ADDENDUM NO. 5
TO THE BID DOCUMENTS
Pioneer Dock Fender Repair
CITY OF HOMER, ALASKA

Addendum Issue Date: February 14, 2023

HOMER PIONEER DOCK FENDER REPAIRS HOMER, ALASKA

ATTACHMENT METHOD A - DOCK PLATE

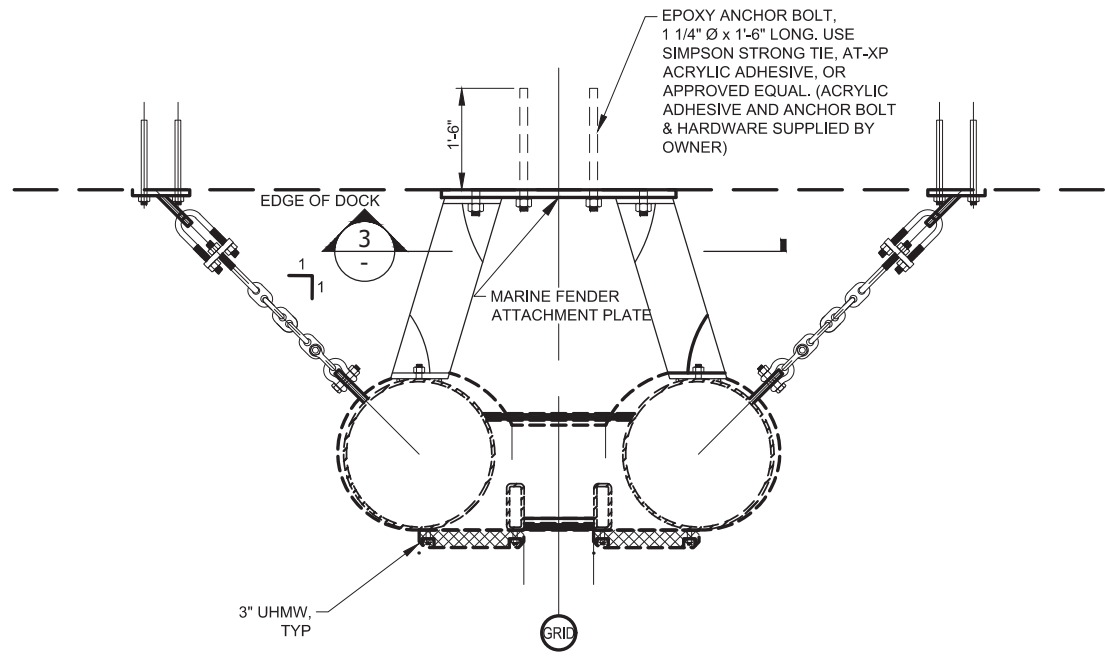
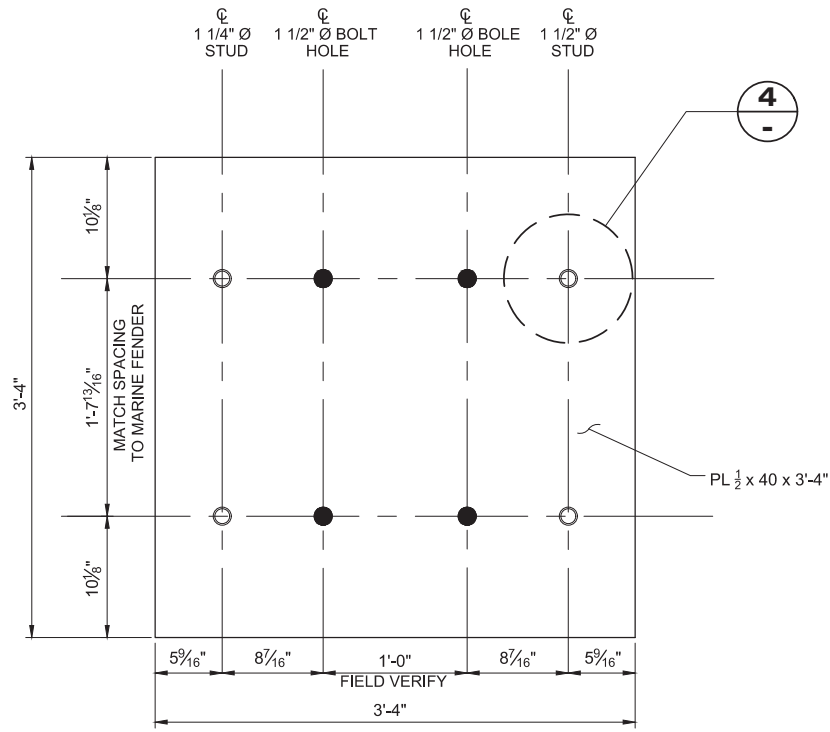
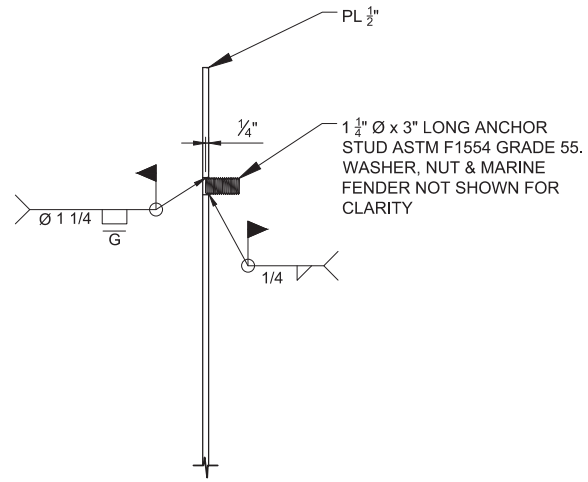
Question #2: Regarding “Attachment Method A – Dock Plate”, page G6. Would it be acceptable to have the plate fabricated with two additional small holes (5/8”), and use them to temporarily bolt the plate to the face of the dock? Then the plate itself can be used as a template for the larger anchor bolt holes.

Answer #2: Installation of additional bolt holes to use as a method to temporarily support the plate to facilitate installation is acceptable.

ATTACHMENT METHOD B - FENDER PLATE

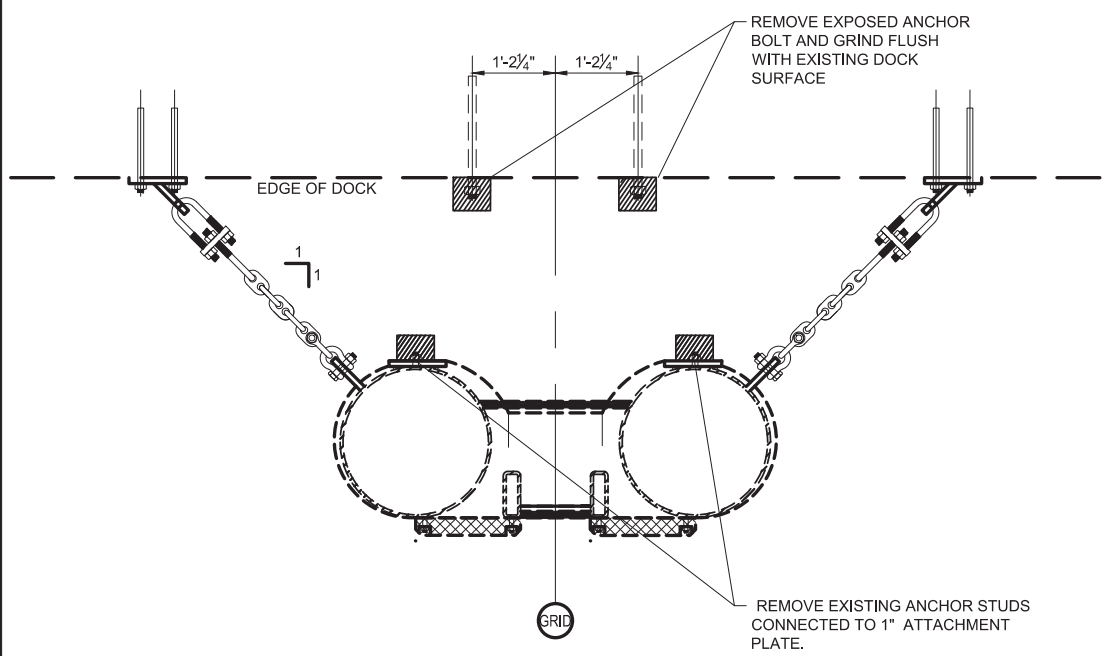
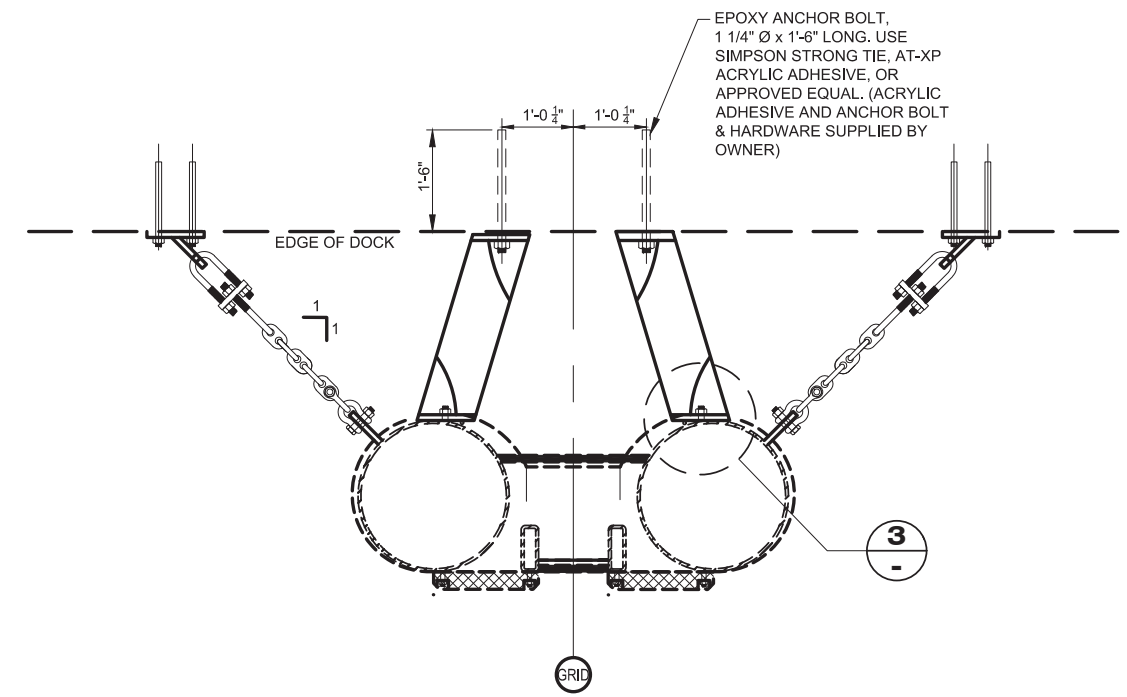
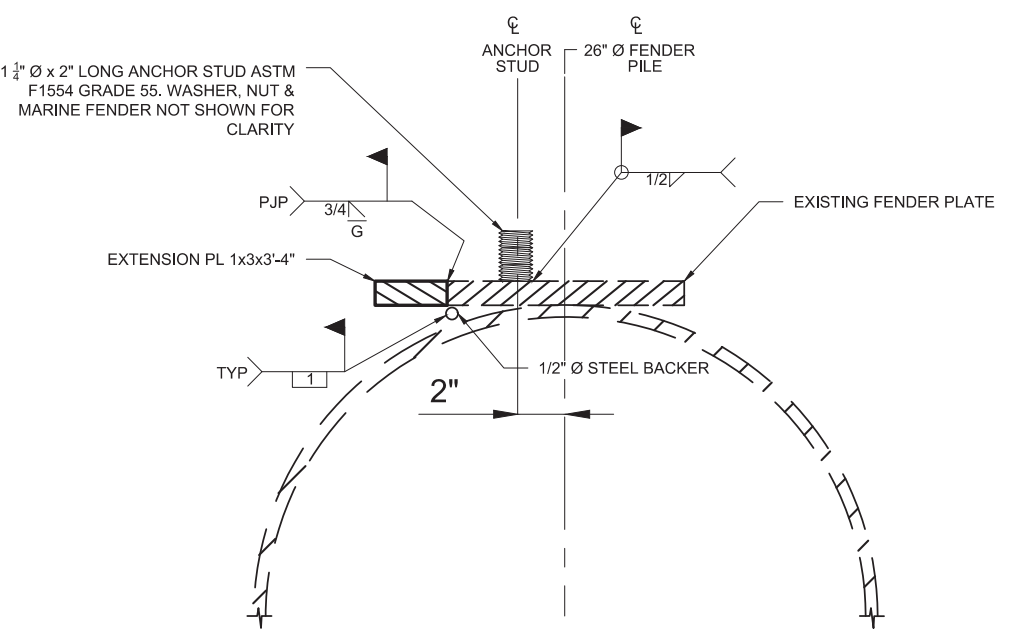
Question #1: Regarding the attachment of the rubber element fenders, what if the dock-side concrete anchor bolts are fine, but the fender-side welded anchor studs need to be repaired or replaced?

Answer #1: If the fender-side welded stud anchors are found to be damaged then they will need to be replaced. Updated plan sheets are attached to reflect this.
